RE: Ōhaupō Private Plan Change – Request for Further Information Response

ATTACHMENT A | CKL TRANSPORT RESPONSE

13 Ryburn Road, Ohaupo – Section 92 (s92) Further Information Request Response

Figure 1 to Figure 3: Pre-development Flood Maps

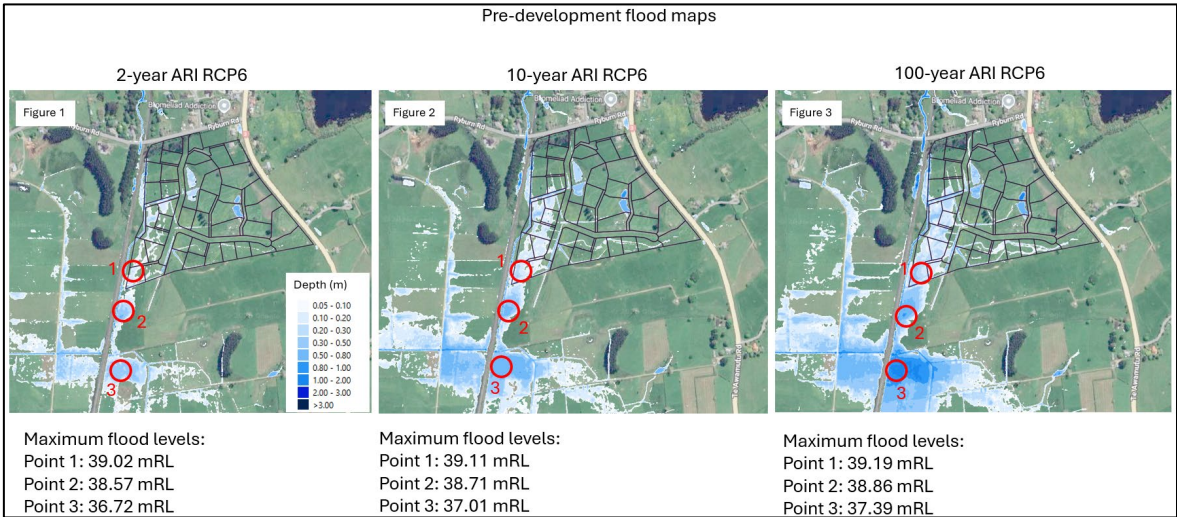
WDC raised concerns about the flood levels for pre and post development scenarios to assess whether or not the generated runoff will be contained within the development and does not impact the adjacent properties or infrastructure.

To assess the displacement impacts, TMW developed a site specific TUFLOW flood model for 2, 10 and 100-year ARI (RCP6) storms. The model includes the flows coming to the site from the upstream catchments, and the pipes, roads and railway culverts crossings, and specifically the Ryburn Road bridge are incorporated into the 2D TUFLOW flood model. The flood maps are provided in **Figure 1 to Figure 6**. Based on the flood levels, and the 100-year flood depth difference (**Figure 7**), it can be seen that the impact of the proposed development on flood displacement is nominal.

Figure 4: Concept Subdivision Intersection Design

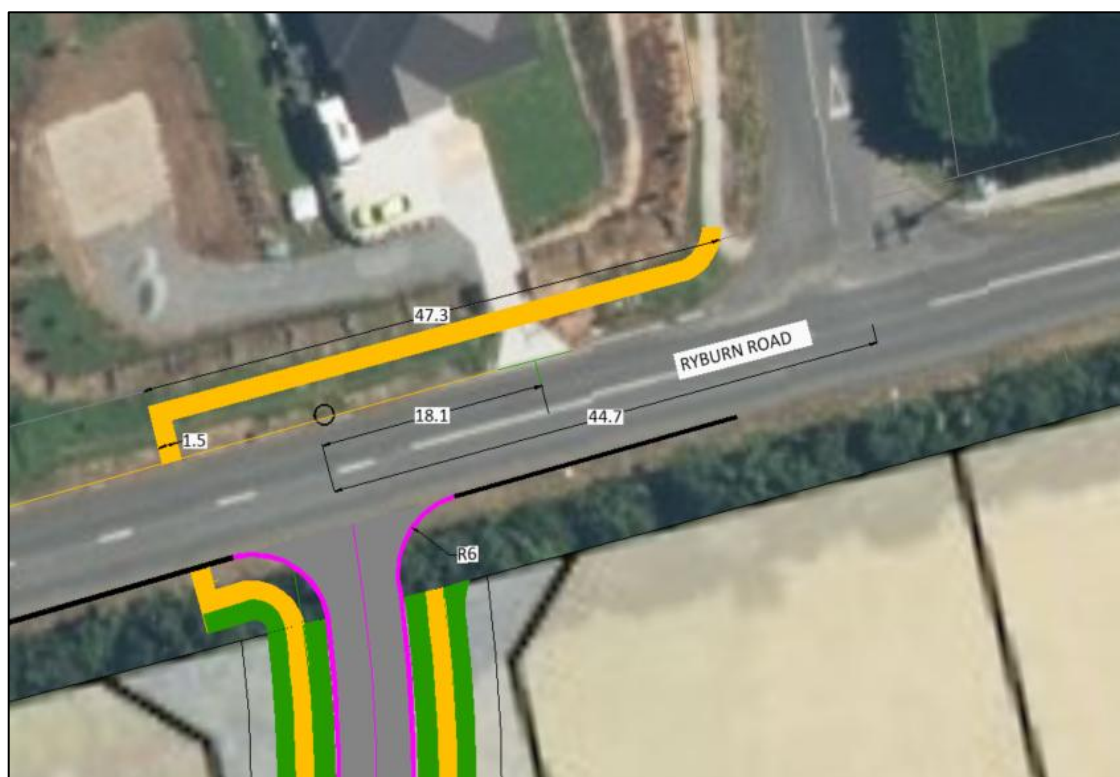
- *The structure plan shows the new intersection close to and opposite the existing vehicle entrance to 24 Ryburn Road. This is non-compliant with RITS for separation between entrances and intersections and creates potential conflicts for intersection and driveway use.*

5. ***Please amend the ITA to evaluate effects of the intersection / entranceway separation and road widening. To this effect the assessment would benefit from the provision of a diagram illustrating the design of the new intersection relative to the requirements of RITS.***

A concept intersection design has been undertaken using both the requirements of WDC District Plan for the provision of a public local road corridor and RITS to provide the required kerb radius. RITS V2 Section 3.3.9, requires the kerb radius in a residential area to be 6m as shown in Figure 4 below. RITS Section 3.3.9.7 also requires the separation distance between opposing intersections on a local road to be a minimum distance of 30m. This separation distance also aligns with the 30m separation distance between intersections specified in WDC ODP Rule 16.4.2.5. The concept design is also able to exceed this separation requirement. A high-level concept intersection design is shown in Figure 4 below.

WDC ODP Rule 16.4.2.5 also requires a separation of 30m between an intersection and an opposing accessway. Figure 4 above demonstrates a separation distance of approximately 18m. This non-compliance occurs within the posted 50km/h section of Ryburn Road and it is noted that there are unobstructed sightlines between the proposed intersection and the existing residential accessway.

The concept intersection design includes the provision of a pram crossing immediately west of the intersection to facilitate pedestrian movements across Ryburn Road. This will also require the provision of an approximately 35m long, 1.5m wide footpath on the northern side of Ryburn Road to the existing footpath on the western side of Charles Edward Street, to be constructed within the road reserve. This provides onwards connectivity to the centre of Ohaupo.
